MIL-F-70518 (AR)
AMENDMENT 3
05 December 1995
SUPERSEDING
AMENDMENT 2
22 August 1990

FLARE, INFRARED TRACKING, MARK 33 MOD 0 (ARMY)
PARTS FOR AND LOADING, ASSEMBLING AND PACKING

This Amendment forms a part of Military Specification MIL-F-70518 (AR), dated 14 December 1984, and is approved for use by the U.S. Army Armament, Research, Development and Engineering Center and is available for use by all Departments and Agencies of the Department of Defense.

FIGURE I: Method for Mounting the MK33 MOD 0 (Army) Flare on the 2.75 Rocket Motor

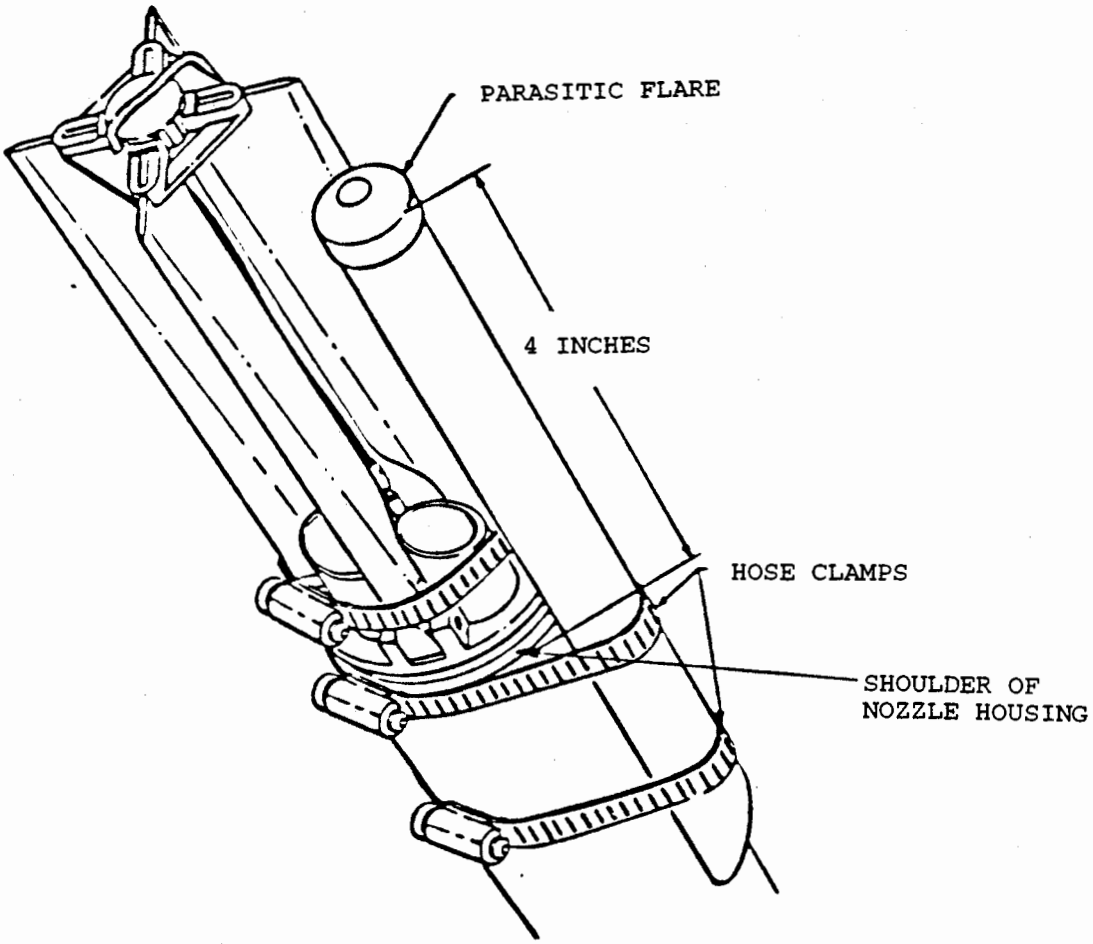
Substitute included "Figure 1".
